APPENDIX K COMMUNITY MEETING #5 JANUARY 24, 2015

AUSTIN CEMETERIES MASTER PLAN

Community Meeting #5 — Summary Report Steph McDougal, McDoux Preservation LLC January 26, 2015

Plummers Cemetery: Vulnerability Allow dirt/gravel cemetery drive to revegetate and keep in mown grass performed in this area 000000 Native boulders, 10' o.c. see 20 scale detail-Native stone 1-2 - 20 above

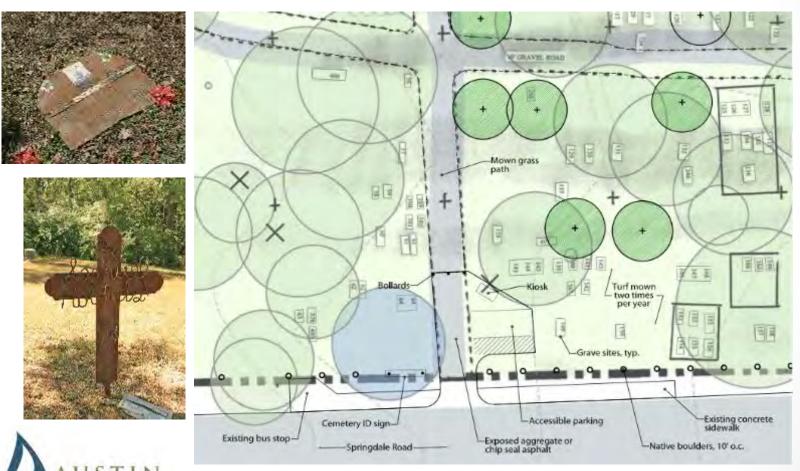
- I am opposed to closing off the cemetery to vehicular traffic because the cemetery is large and the landscape is rolling; it would be a precarious, difficult walk for visitors to reach graves.
- I do not like the boulders. Why are there boulders here but fences everywhere else?
- Parking is needed along Springdale Road, along the bike path.
- Consider a driveway loop or, alternatively, two entrances on Springdale Road.
- Where is the plat information for this cemetery?
- If a remote sensing survey is conducted, have a permanent marker for each of the likely unmarked graves. Even if it is small, the local community would want to know where their predecessors are.
- Austin has actively tried to marginalize this community, so please do not forget about Plummers Cemetery.
- It was not a rural cemetery. It was the center of the community for east Austin.

Evergreen Cemetery: Appearance and Entrance

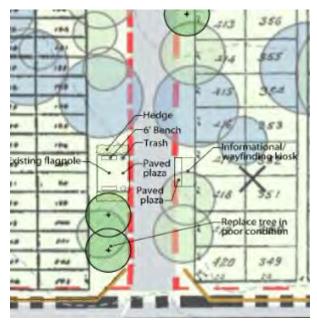
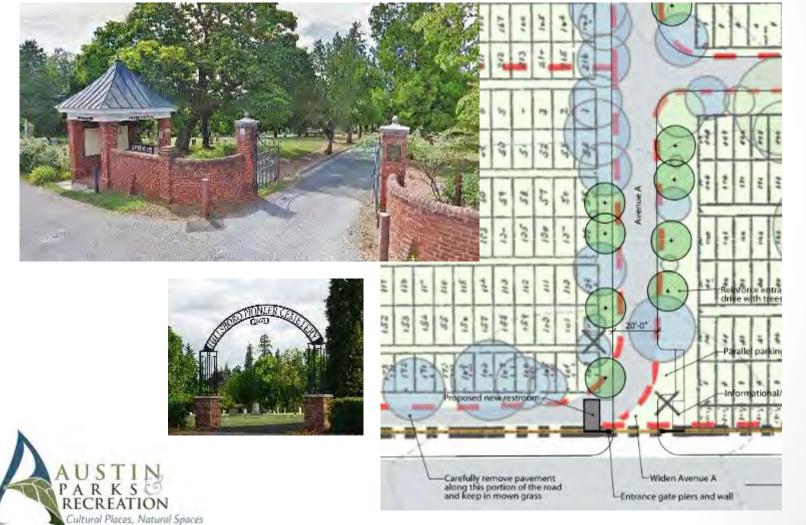
- If a garden area is added under the old oaks by the current entrance, please stay away from the critical root zone (a circle with a radioum of 1 ft per 1 inch of trunk diameter measured 4.5 feet from ground) to avoid soil compaction from people. Those oaks are doing well because very few people walk in that area. Mulch these trees to the edge of the canopy with no more than 3 inches of mulch and keep people away by not adding features or walks under these trees. Same for all very large trees, specially post oaks and live oaks. Thanks for caring for the trees!

- If there is going to be an entrance on Tillery, we need a sidewalk on that side of the street as well as speed bumps. Cars drive very fast through there and it's dangerous.

- Concerns about how funeral processions would be able to use the Tillery entrance and how that would affect traffic when processions are trying to turn onto Tillery from 12th Street.

- Important to keep the main entrance on 12th Street. If you add a gate or sign over an entrance, it should be at he 12th Street entrance because that is the historical entrance and the prominent families are buried there.
